PLANNING BOARD

Tuesday, January 9, 2024 at 4:30 PM
Hybrid Meeting, Room 24 (Basement
Level of City Hall) and Zoom

- ii. Major Site Plan and Conditional Use; 19 West Street; Carleton West, LLC, Applicant. The Planning Board will hold a hybrid public hearing to consider a proposal to redevelop an 8,360 square foot medical office building as a five-unit residential building, and construct two separate duplex structures on a 0.86-acre property addressed at 19 West Street, with frontage on Carleton Street. The project also involves the construction of 18 new parking spaces, and would further retain 23 existing parking spaces for use by neighborhood residents. The property is zoned R-6 residential, and is also located within the West End Historic District. A project and plan summary are available for viewing on the city's CSS Portal (<https://css.portlandmaine.gov/>) by referencing Plan Number PL-002614-2023 and CU-002693-2023.

A1.25		Date: 12-4-2023	Scale: 1/4" = 1'-0"	Revisions:	Project: 19 WEST ST. PORTLAND, MAINE	Architect: ARCHETYPE ARCHITECTS 48 Union Wharf Portland, Maine 04101 207.772.6022 archetype@archetypepa.com	Consultant:		Prepared For:	Address City, State

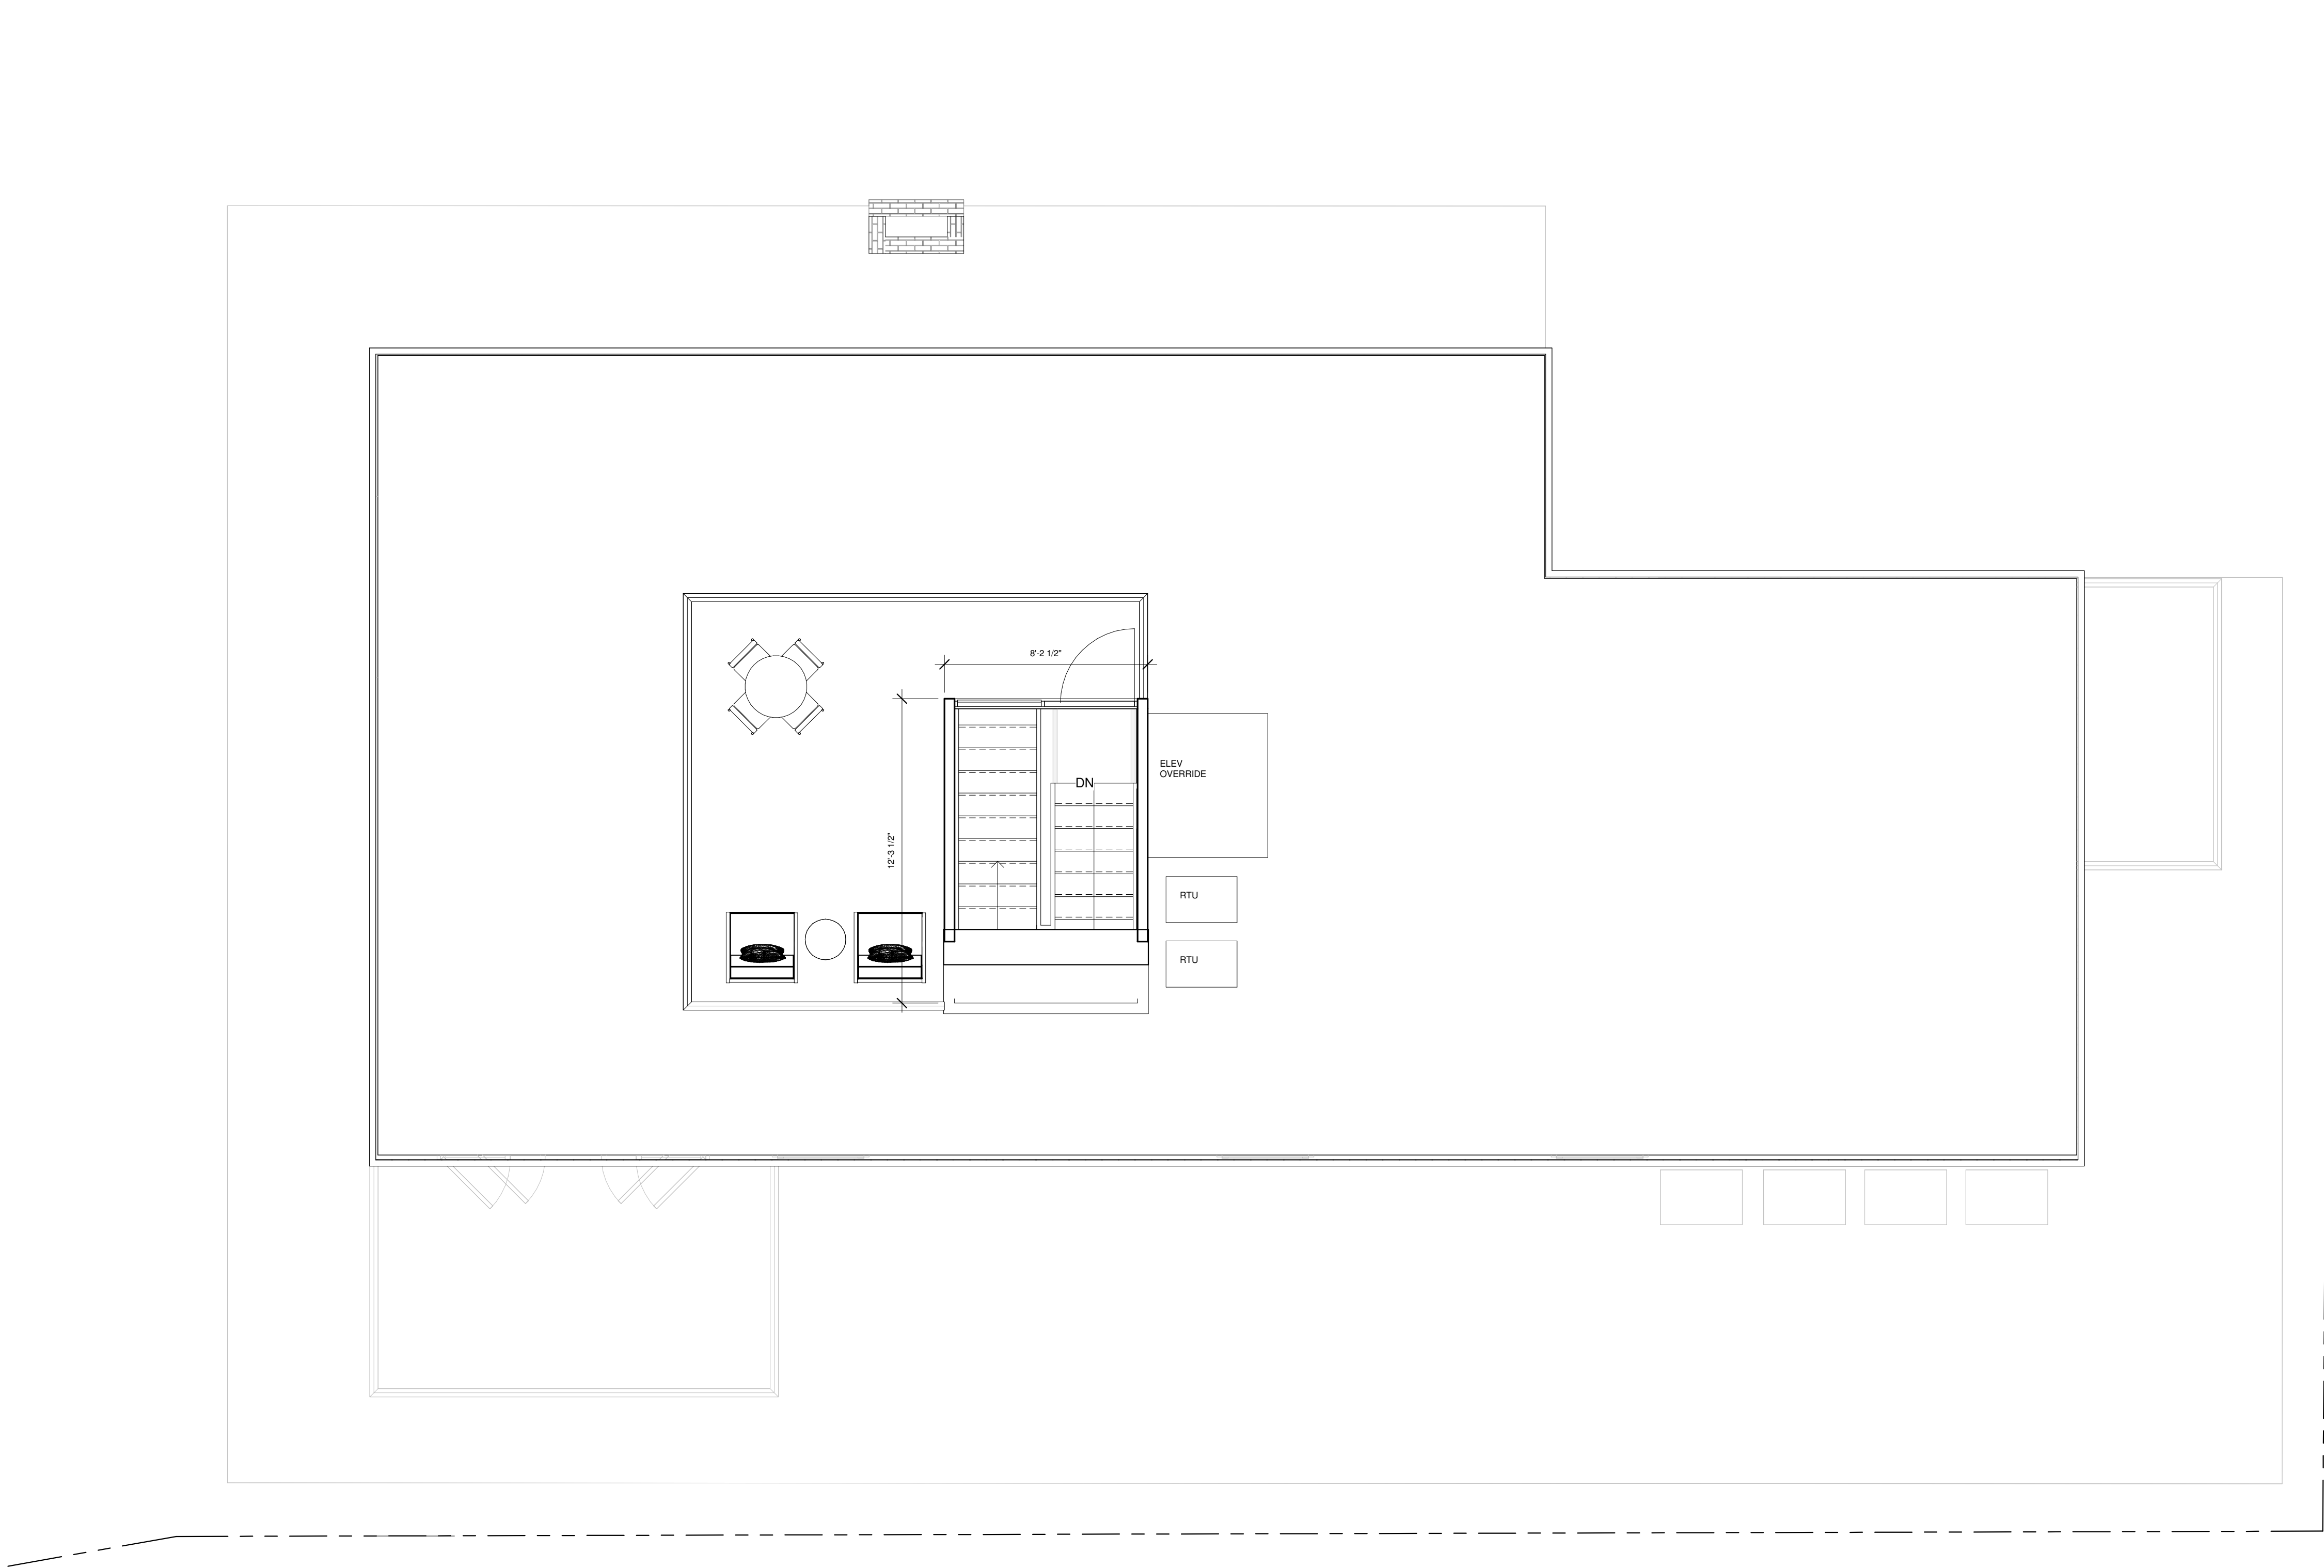
- Plan A1.25 shows what appears to be a spiral stair accessing the roof deck on the 19 West building (round figure). How does it change to a spiral stair from the fourth floor?

Revised Plans: A1.25, A2.23

1 Front Elevation
1/4" = 1'-0"

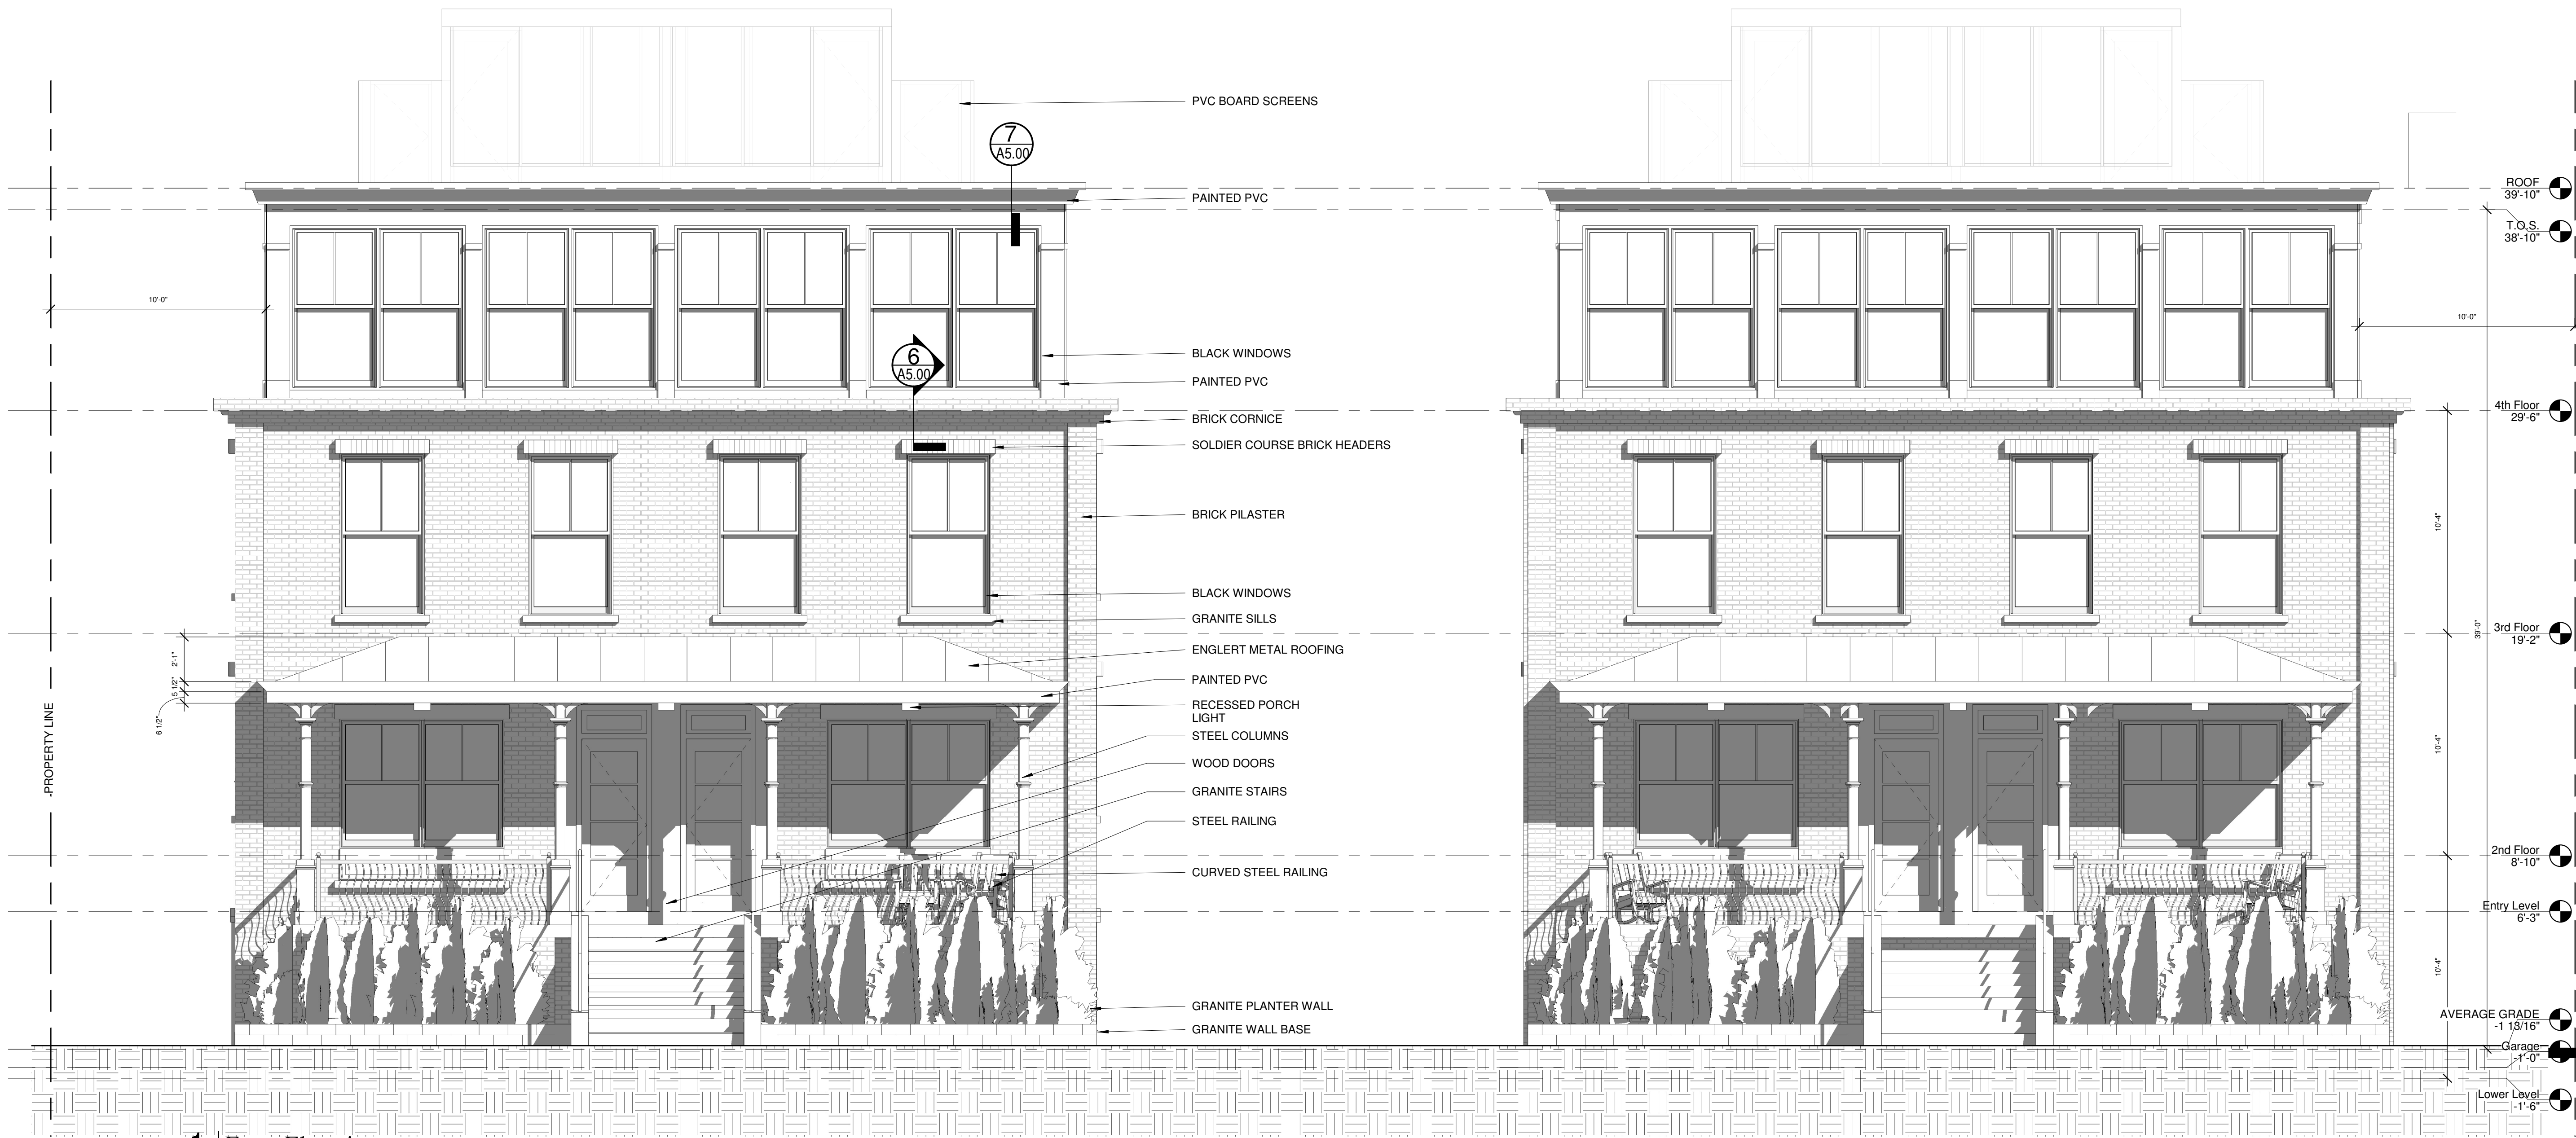
- The revised front elevation (A2.01) shows the 10' stepback from the left side property line but it does not show the 10' stepback from the right side property line. Please revise the plan.

Revised Plans: A2.01
